## ROSE SENIOR LIVING AT PROVIDENCE JSP13-81

Public hearing at the request of Edward Rose and Sons for Preliminary Site Plan, Wetland Permit, Woodland Permit and Stormwater Management Plan approval. The subject property is 23.61 acres in Section 17 of the City of Novi and located on the north side of Eleven Mile Road and west of Beck Road. The applicant is proposing a 182 unit senior living facility.

Approval/denial of the Preliminary Site Plan, Wetland Permit, Woodland Permit and Stormwater Management Plan.

**Figure 1.** Site Aerial Photo (City of Novi Map Gallery, assessed March 10, 2014. Approximate project boundary shown in red). Regulated woodland areas are shown in green and regulated wetland areas are shown in blue.

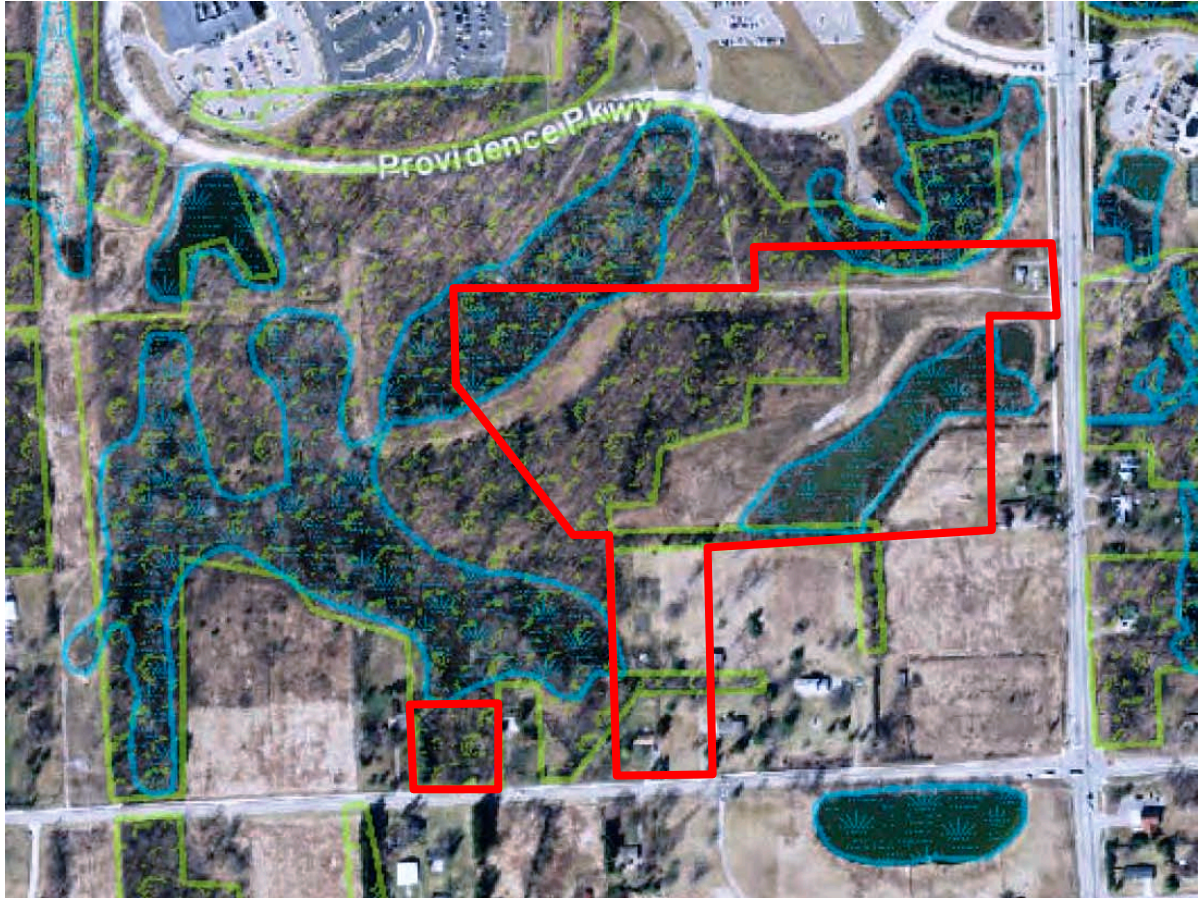
The entire site is shown to be 23.61 acres with regulated woodland mapped across a significant portion of the property. See Figure 1 (aerial photo).
